Palo Verde Nuclear Generating Station Seismic Hazard Re-evaluation

NRC Public Meeting
Rockville, Maryland
June 9, 2015

Geodetic Extension Rates (in mm/yr) and % of extension that can be explained by fault slip rates

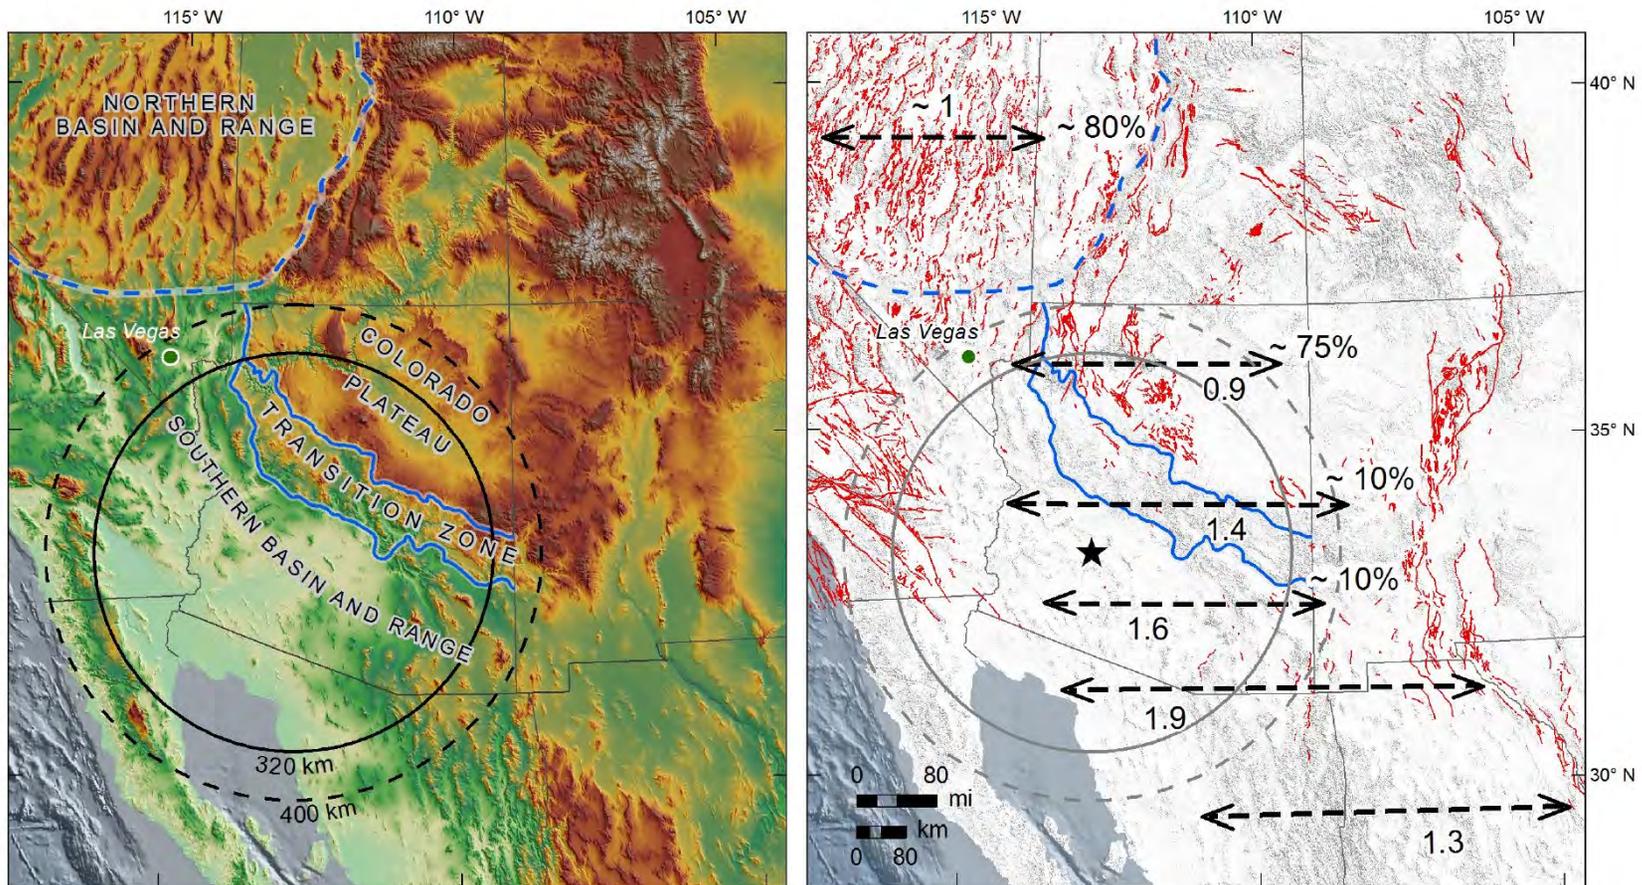
NRC SSC Q1: *Provide clarification on how the uncertainty derived from the difference in cumulative slip rates on Quaternary faults in Arizona in comparison to the geodetic slip rates in southern Arizona were evaluated and incorporated into the model. In addition, explain why faults that were originally part of the USGS National Seismic Hazard Mapping Project (NSHMP) and that are now part of the PVNGS SSC include alternative possibilities for geologic and geodetic slip rates while other PVNGS SSC faults that were not included in the NSHMP do not consider geodetic slip rates.*

The differences in geologic and geodetic rates were evaluated in the following manner:

- Obtain E-W geodetic extension rates from Resource and Proponent Expert Corne Kreemer
- Compared to transect in central NV where fault slip rates and geodesy match (Koehler and Wesnousky, 2011)
- Evaluated the likelihood that faults are not expressed geomorphically (How many faults can hide in landscape? At what rates?)
- Evaluated how many faults required to produce geodetic extension rate
- Compared geodetic extension rates to strain rates implied by seismicity in source zones

SSC Focus Area Q2c Response

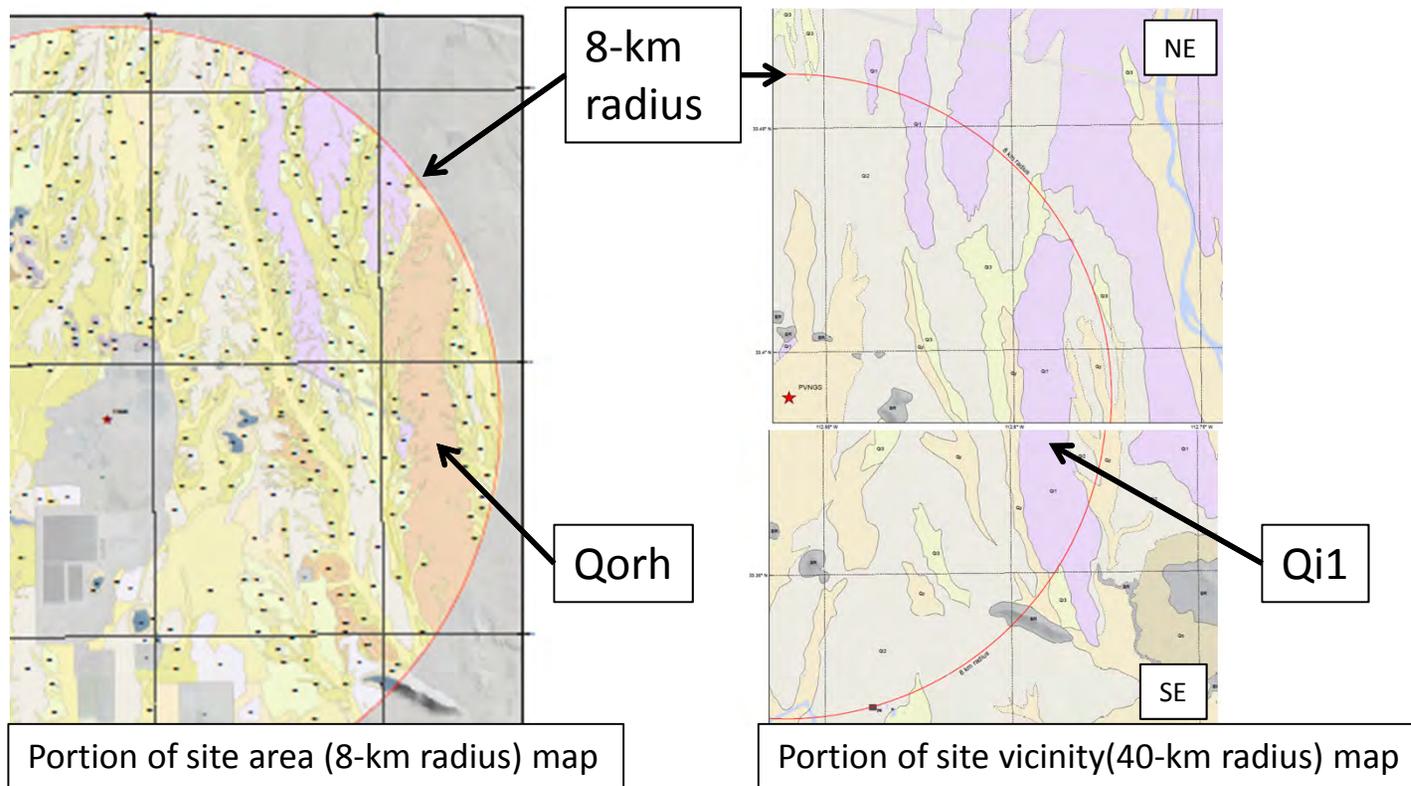
NRC SSC Q2c: *explain the apparent mismatch of units between the site area map and the site vicinity map along the north-south trending Qorh river terrace (along the eastern side of the site area map) with the Qi1 alluvial fan surface (to the north and the south of the Qorh unit on the site vicinity map)*

- The 8-km site area map is based on Pearthree et al.'s (2006) mapping of the Wintersburg quad, expanded to cover the entire site area
- The eastern portion of the 40-km site vicinity map is based on 1:100k mapping by the AZGS, modified by Phil Pearthree for this project. The western portion is based on original mapping
- The apparent mismatch between units is a function of comparing maps produced at two different scales with two different levels of detail
 - Simplification and lumping of units in the site vicinity map
 - Site vicinity map does not include small polygons and thin "veneers"

SSC Focus Area Q3b Response

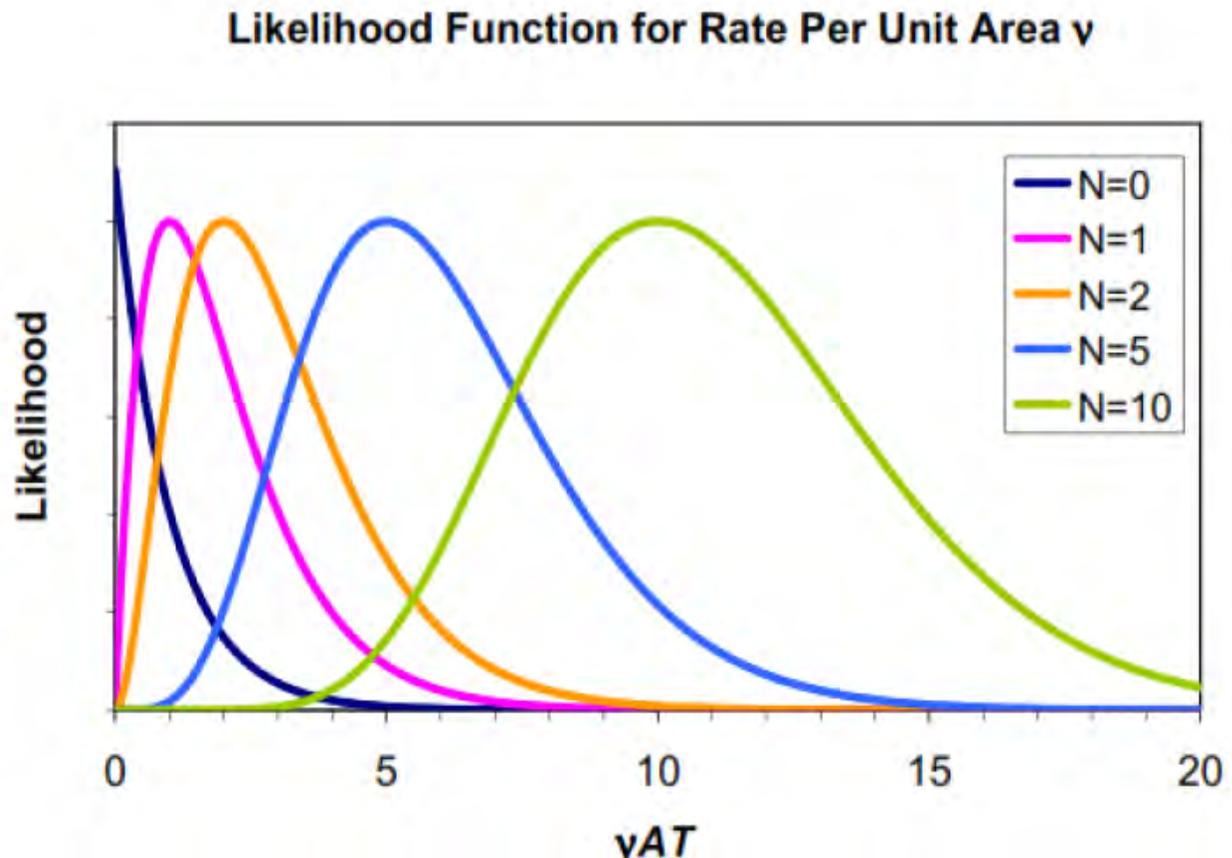
- b. not using a floor during the smoothing analysis of recurrence parameters as the host zones and other zones have cells with a rate of zero*

- The cells with zero rate occur only in alternative realizations of the recurrence maps (as a way to represent uncertainty in rate), **not in the mean recurrence maps**
- The penalized likelihood approach introduces a “natural floor” by modeling the entire likelihood function of the rate

AS and DS Methods

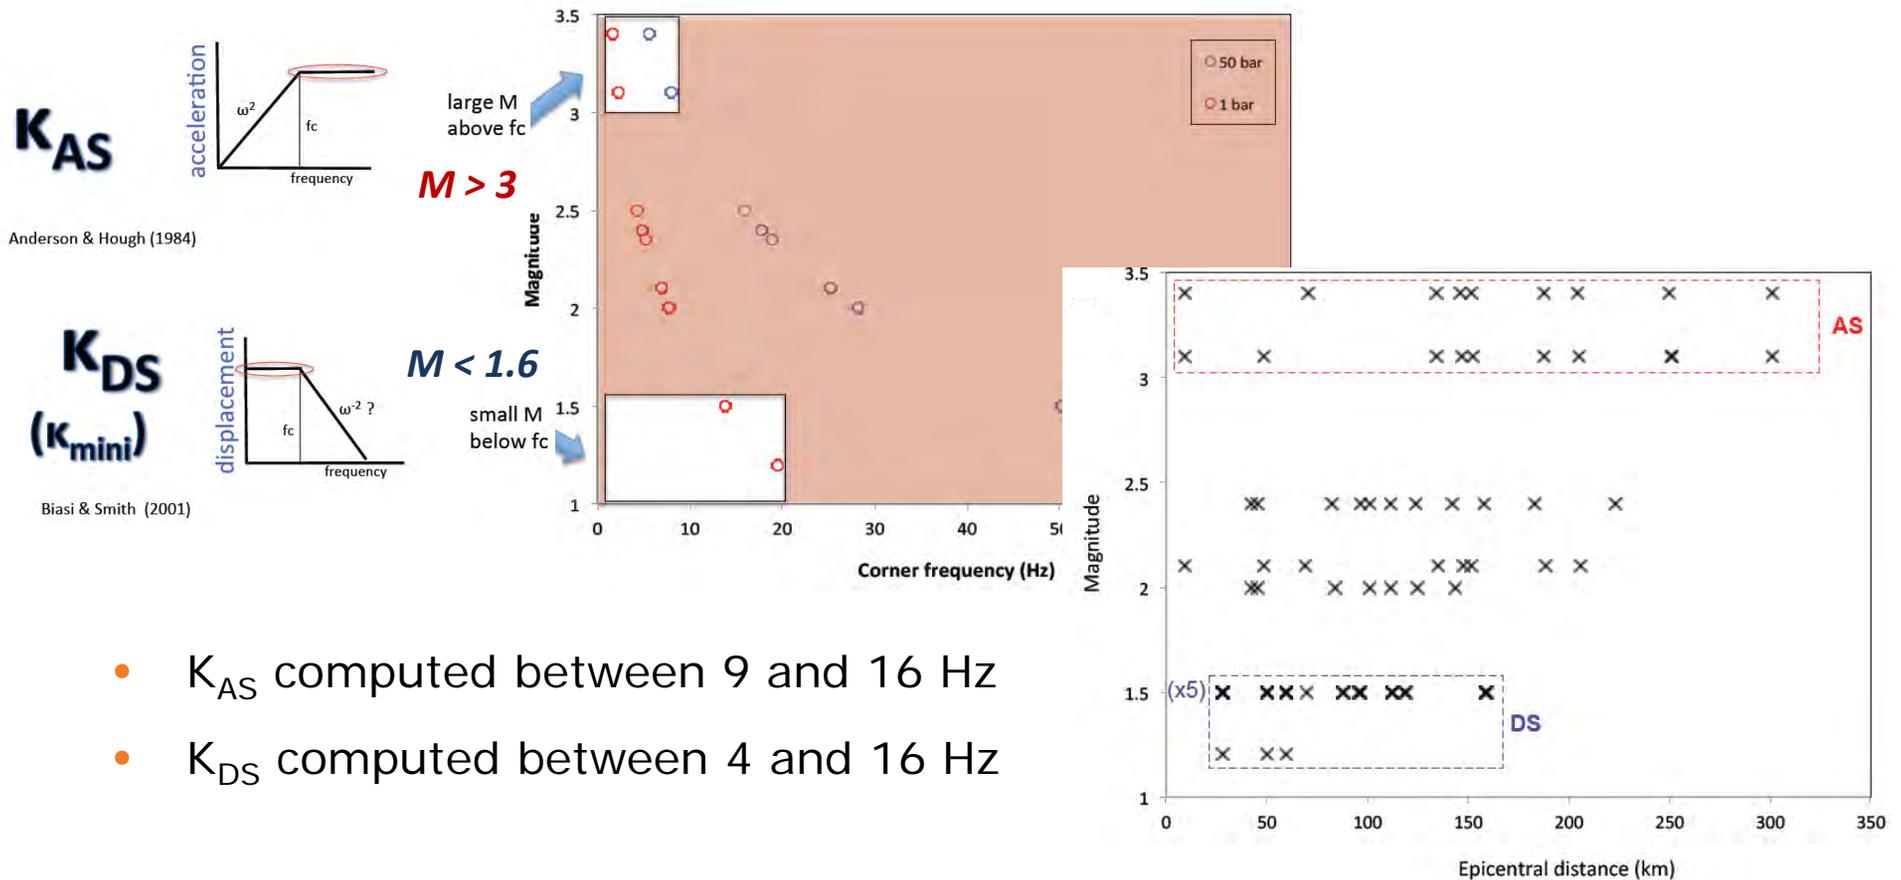
NRC GMC Q1: *Considering the limited bandwidth of the data recorded by the TA array, provide additional detail on the process used to estimate the target site kappa values and their uncertainties. In addition, describe in more detail how the site amplification at the recording stations was accounted for in the estimates of site kappa.*

- Combine the two methods to capture uncertainty

Comparison of Q values from earthquakes located in Regions 1, 2, and 3 to stations in California and Arizona at a rupture distance of 200–400 km.

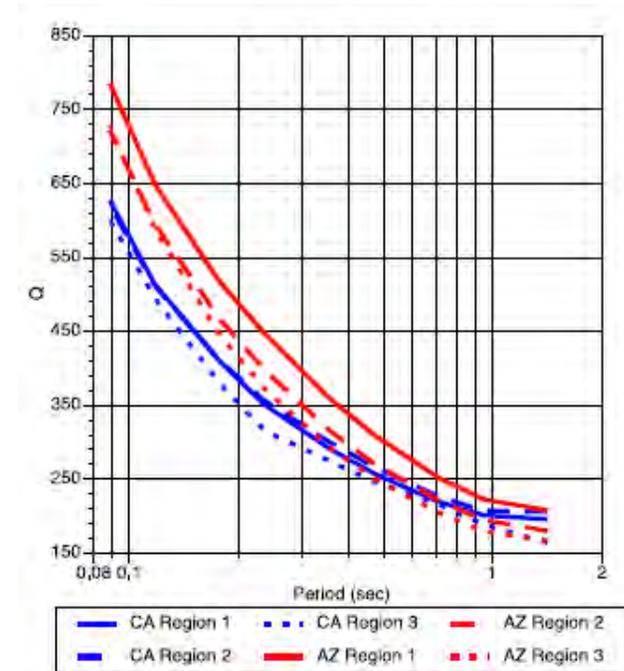
NRC GMC Q2: *Provide additional detail regarding the evaluation of candidate GMPEs for PVNGS for distant California and Mexico sources. Specifically, describe in more detail the evaluation of Kishida et al. (2014) of the potential effects of the Q differences on the ground motions, which provides justification for the conclusion that although there are differences in Q between California and Arizona, these differences do not lead to a significant discrepancy in the average distance attenuation over the distance range of 200-400 km.*

- Path weighted attenuation (sum of $1/Q$) in the 200-400 km range
 - 14 NGA-West2 events with epicenters in CA recorded by stations in CA and AZ
 - Q differences between CA and AZ are visible for short periods, but disappear at longer periods
 - CA events contribute to PVNGS hazard at long periods ($T > 0.5 - 1$ sec)

Changes in Q between CA and AZ are negligible for hazard-significant frequencies

Limitations in Bindi et al. (2014) GMPE

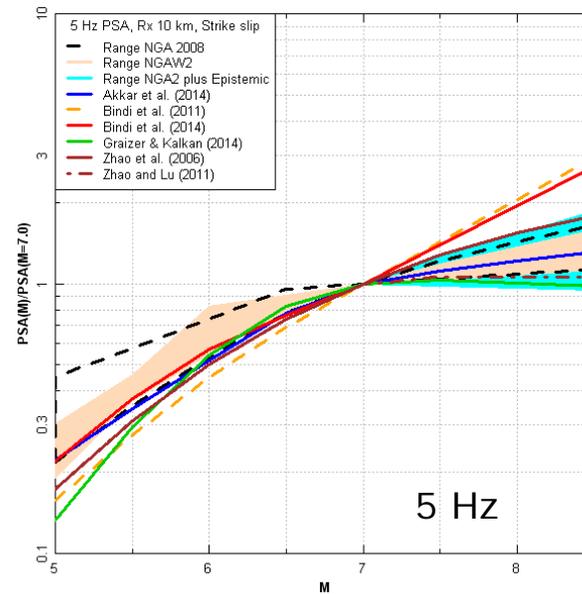
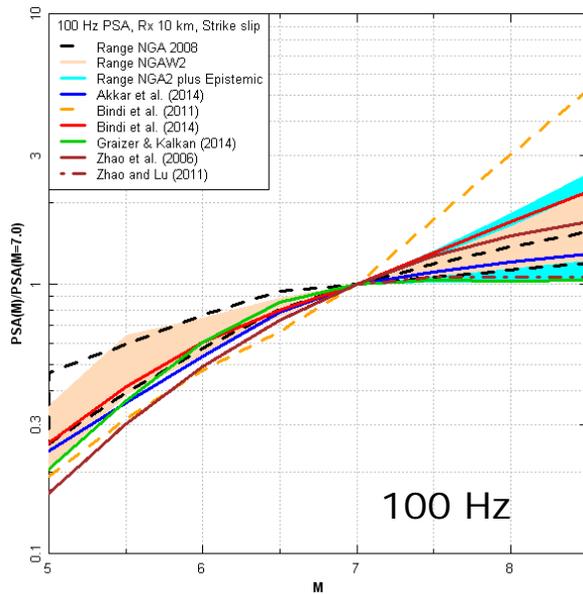
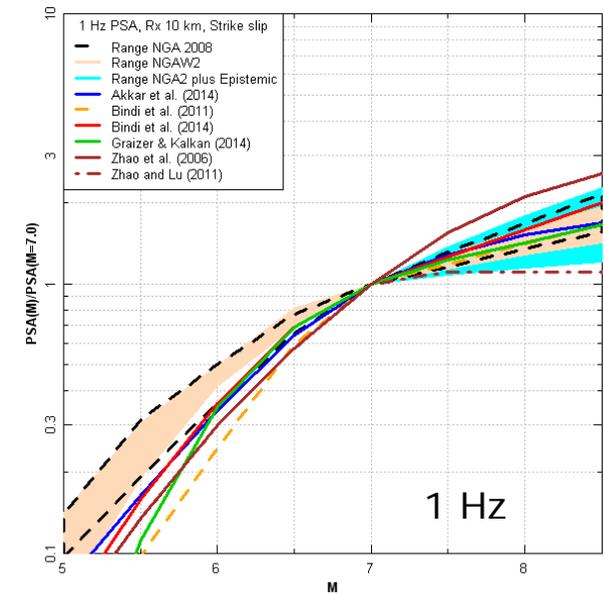
NRC GMC Q3: *With regard to the candidate GMPEs for PVNGS for the Greater Arizona Sources, provide additional rationale for limiting the use of the Bindi et al. (2014) for magnitudes greater than M7.*

- Problematic intermediate-frequency magnitude scaling ($M > 7$):
 - Apparent in the 2011 version
 - Resolved for PGA in the 2014 version, but not for 5 Hz
 - Application limited at $M7$ for all periods

Top portion (andesite, basalt, flow-breccia, and tuff)

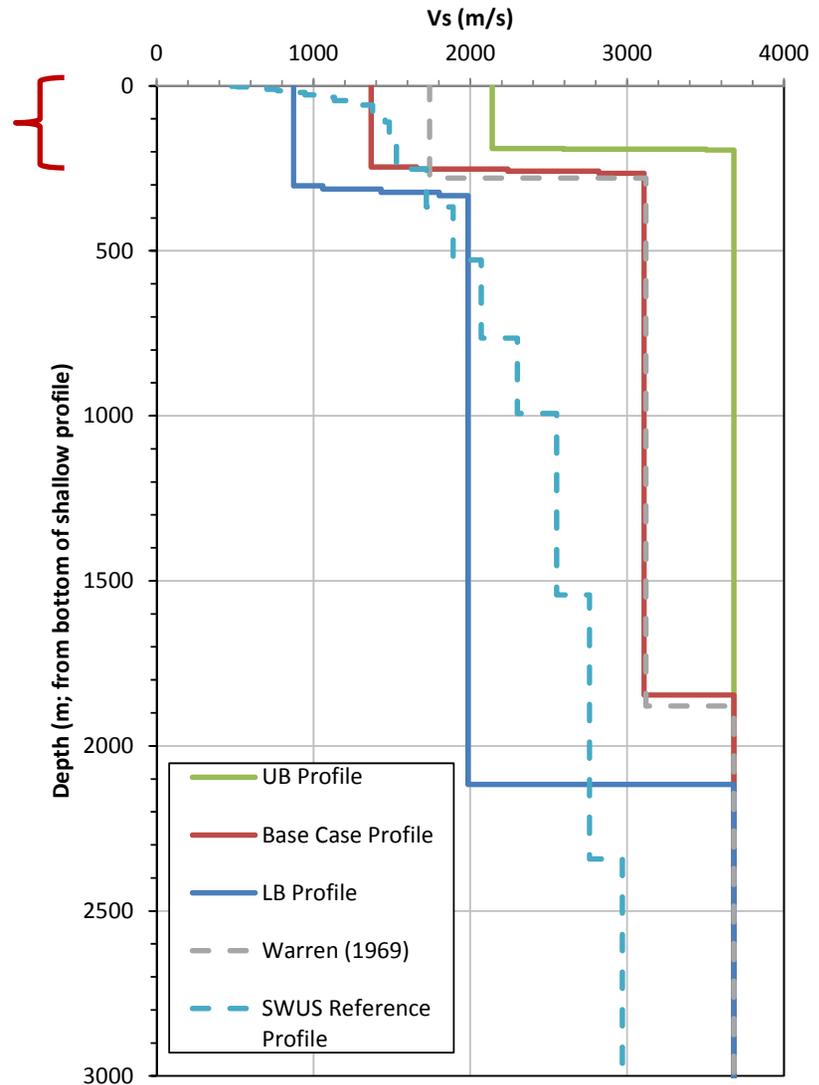
- b. the target deep Vs profile (including the use of a logarithmic standard deviation of 0.35 to develop the upper and lower profiles)*

- Vs from suspension-log data (LCI-B-2 profile)
- Thickness (& uncertainty) from UFSAR boreholes (consistent with Warren, 1969*)

Site Response Focus Area Q1f Response

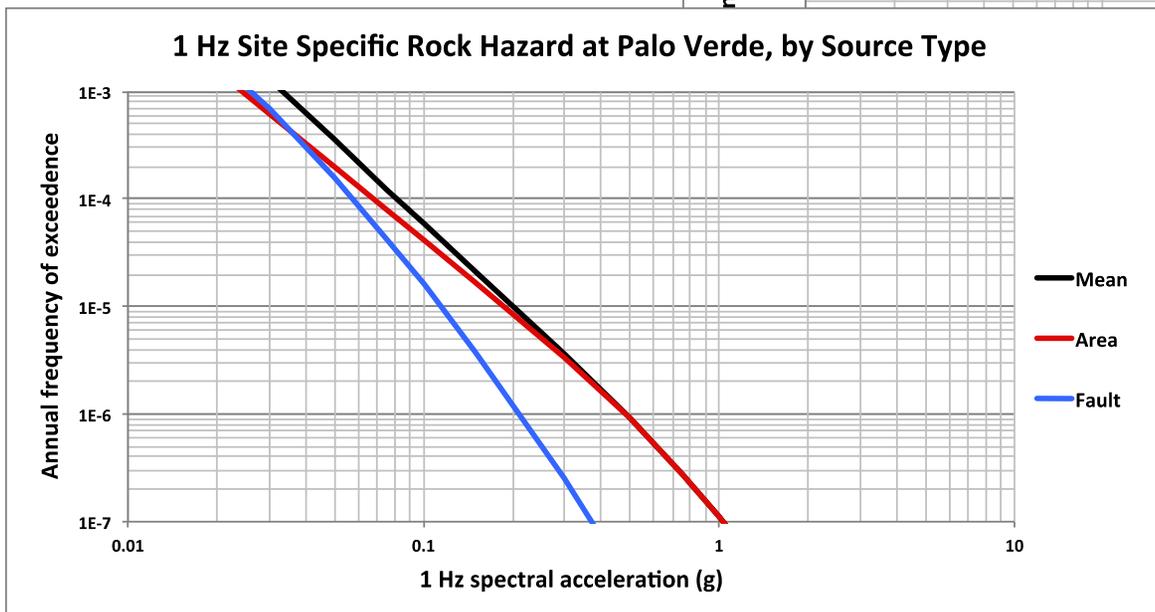
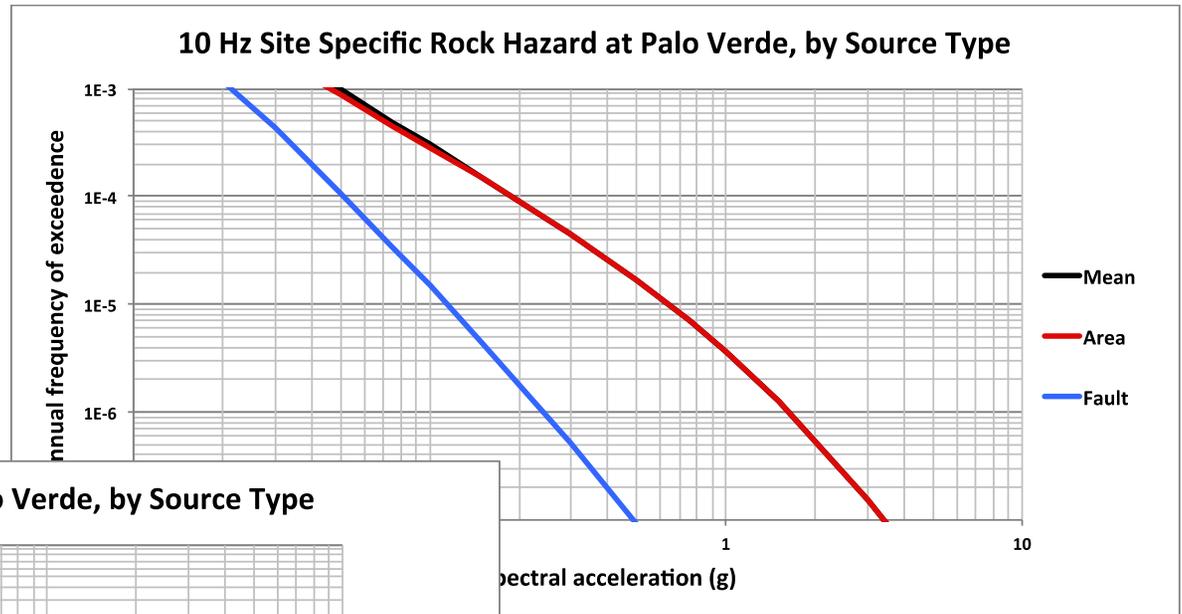
- f. not including the V_s -kappa adjustment factors as additional epistemic uncertainty on the median GMMs instead of capturing this variability as part of the variability in the site amplification functions*

- Because NUREG/CR-6728 Approach 3 was used to convolve the rock hazard and site response, decision to include uncertainty in V_s -kappa adjustment factors as an uncertainty in the amplification functions has no effect on the mean hazard (→no effect on the GMRS)
- This decision was made for the sake of computational efficiency in hazard calculations
